TENDER 19-08

HWY 19A PHASE III WATERMAIN & FORCEMAIN

ADDENDUM NO. 2

March 28th, 2018

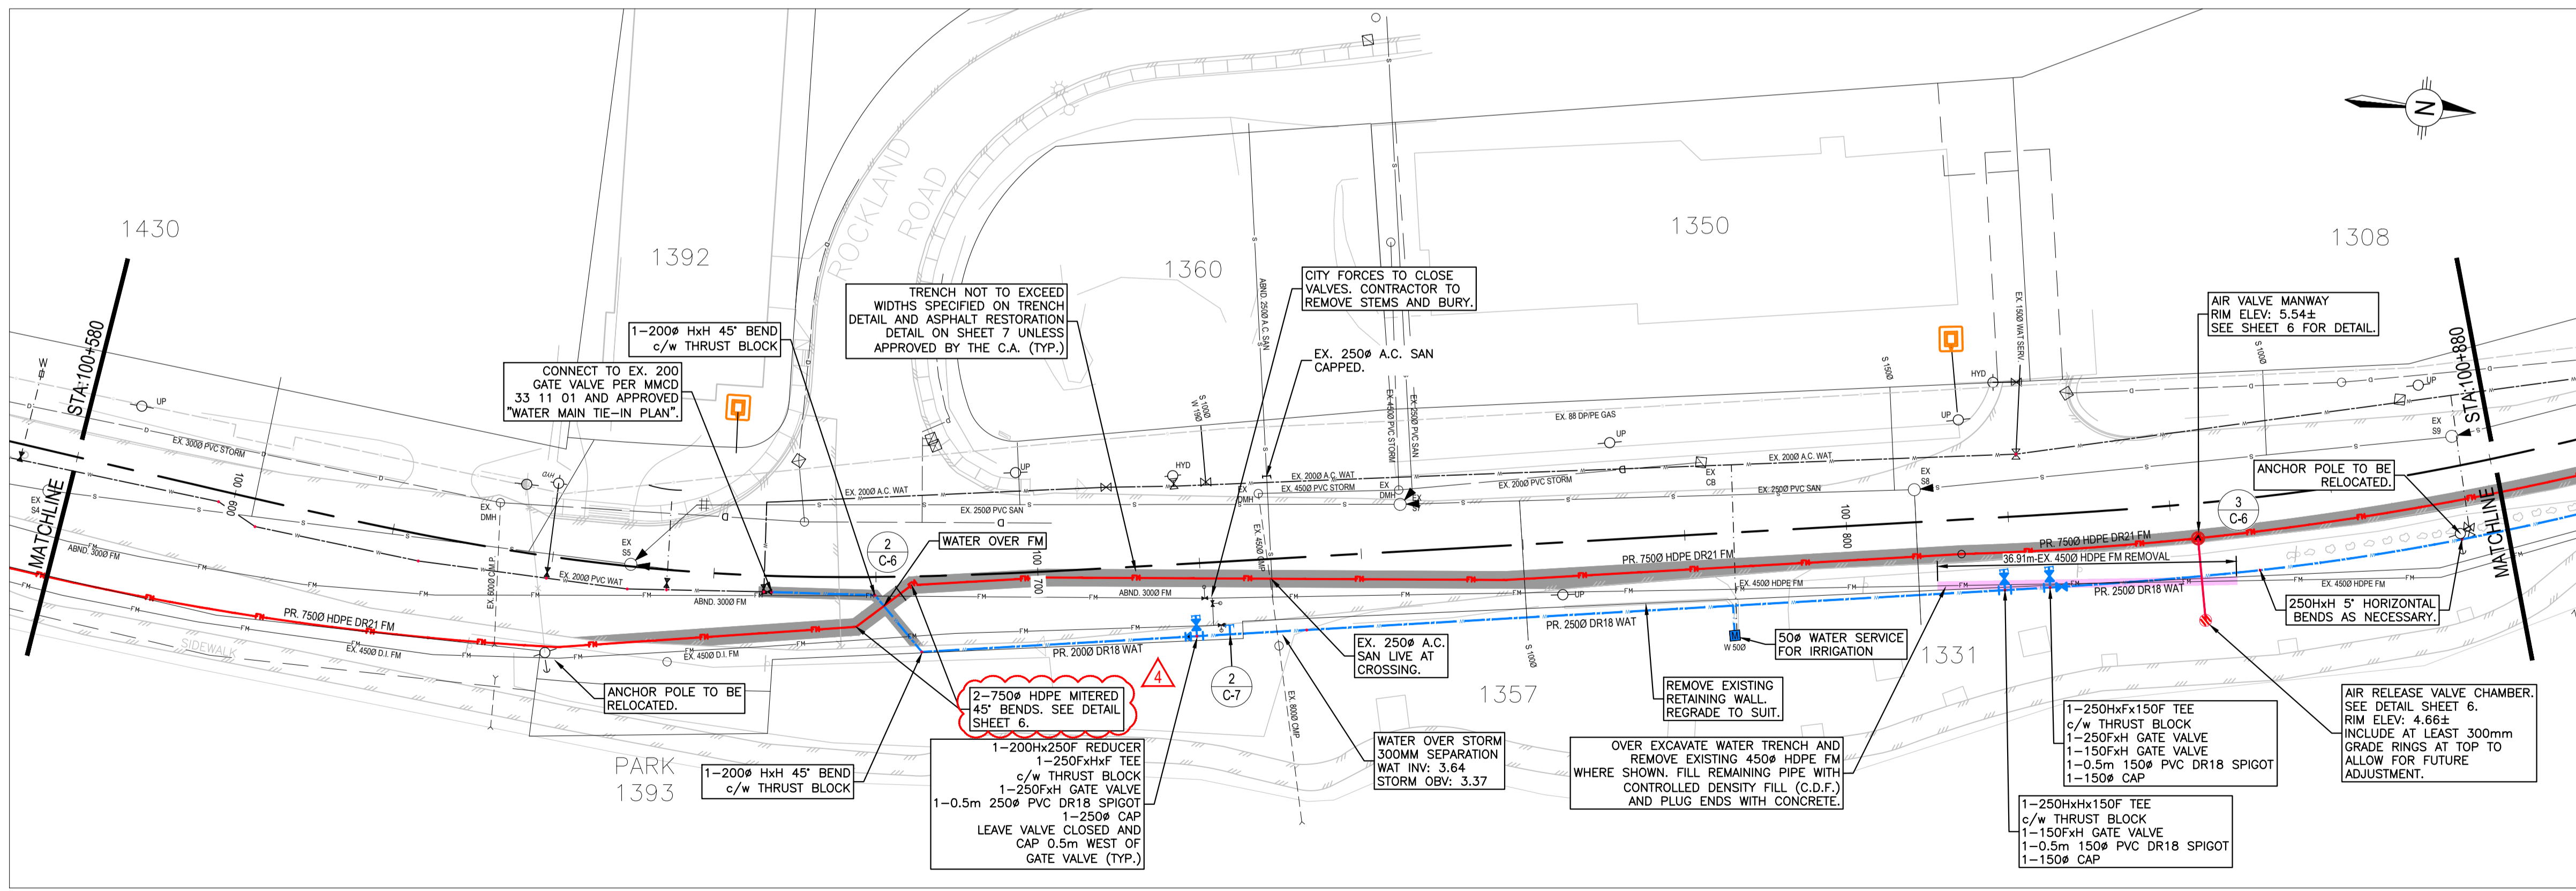
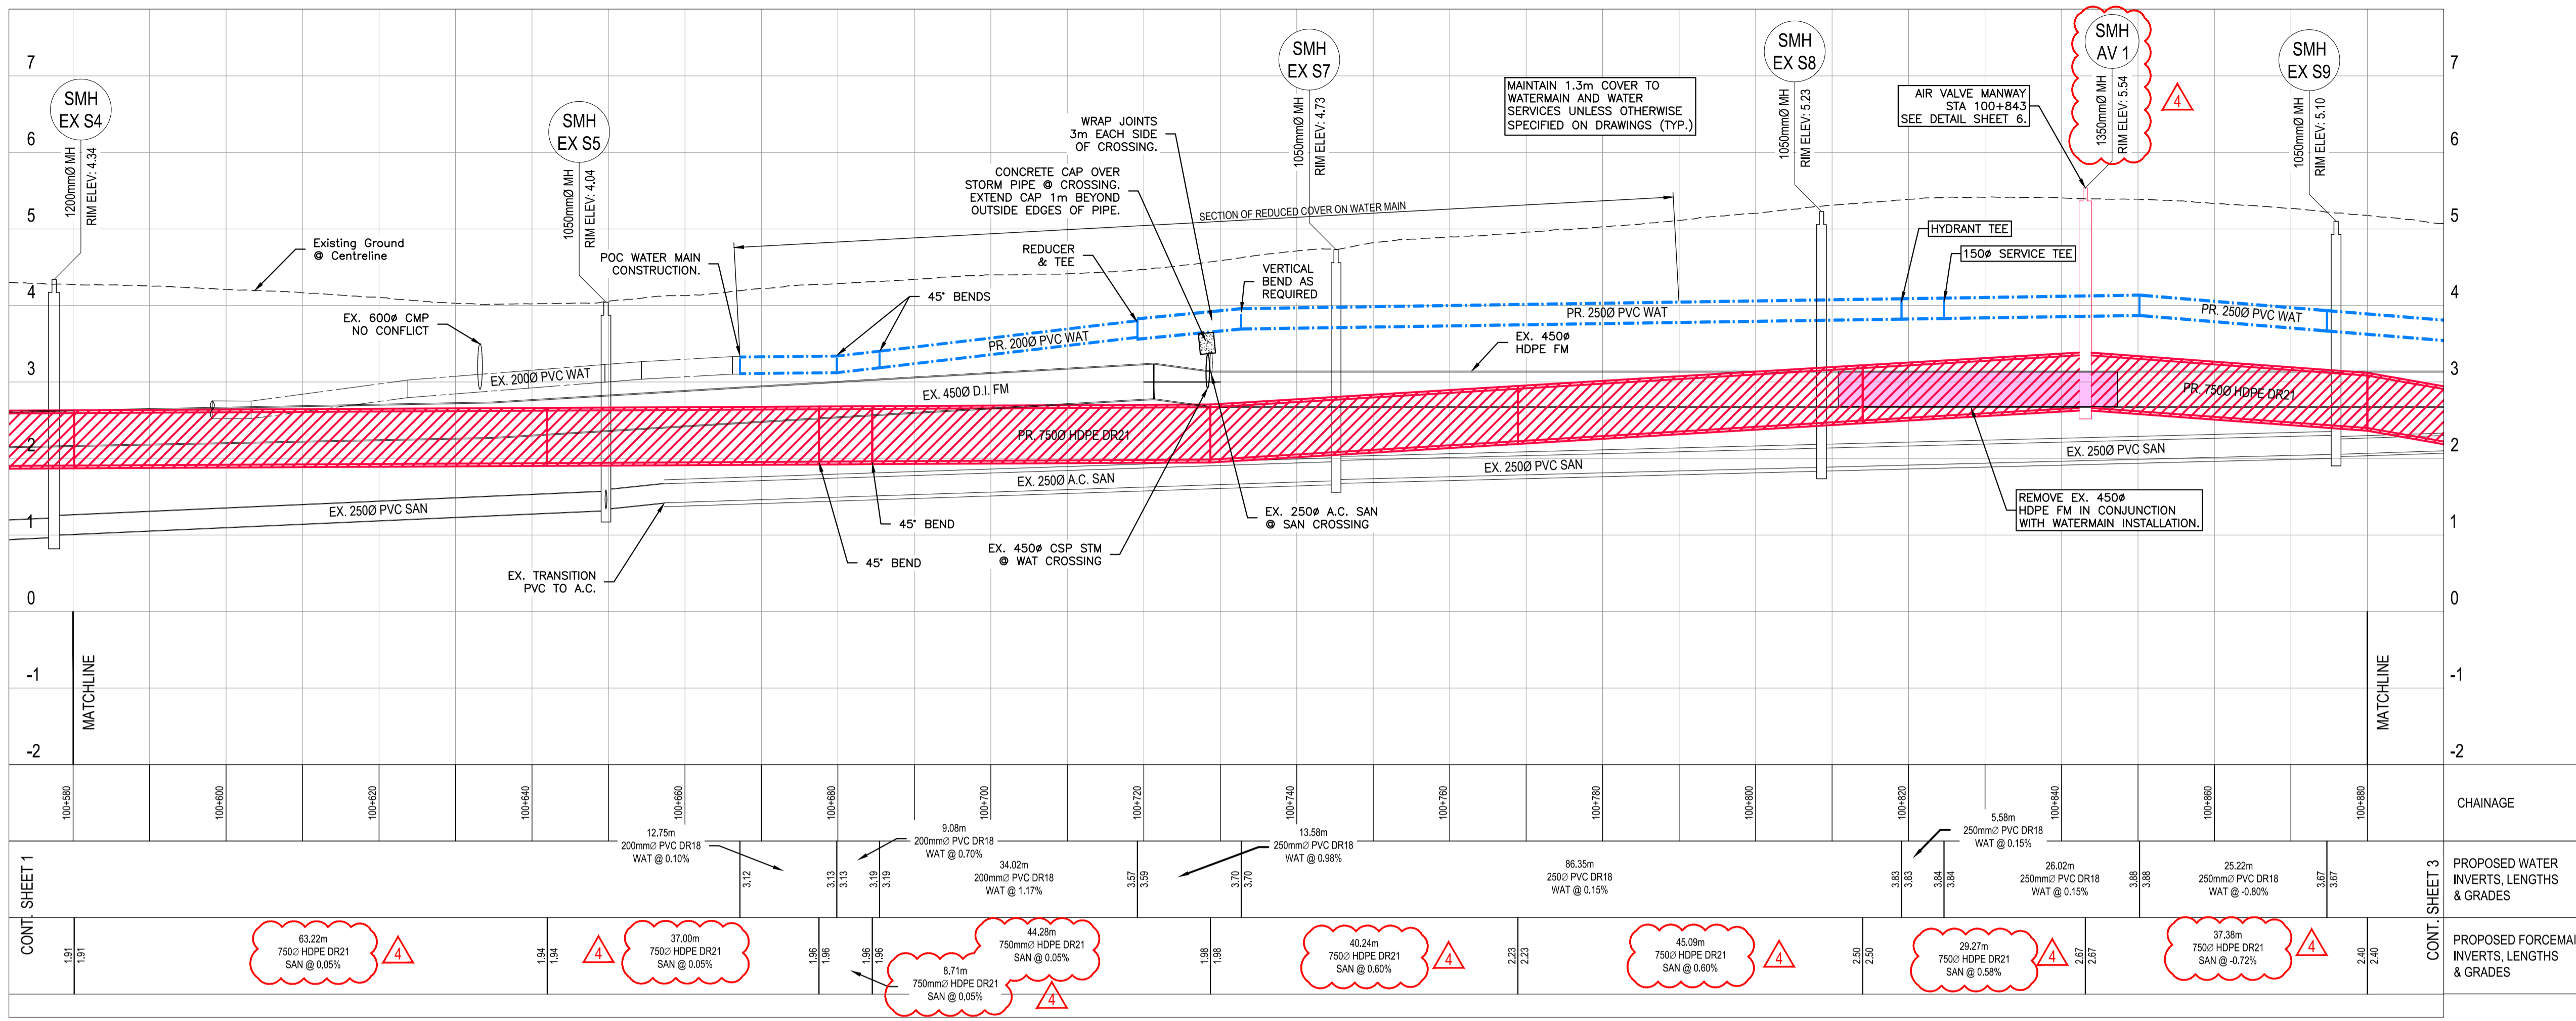
On drawing 2 of 7, sta 100-720, there is a note stating that the “existing 250mm AC sanitary is live at crossing”. Could you confirm this? The drawing also indicates that this AC sanitary main is already capped and abandoned upstream of the crossing point. I refer to the note behind the east curb line.

The 250AC sani main is abandoned westward of the cap and remaining stub connects to the 450mm dia forcemain that is in service. For this reason it is shown as live.
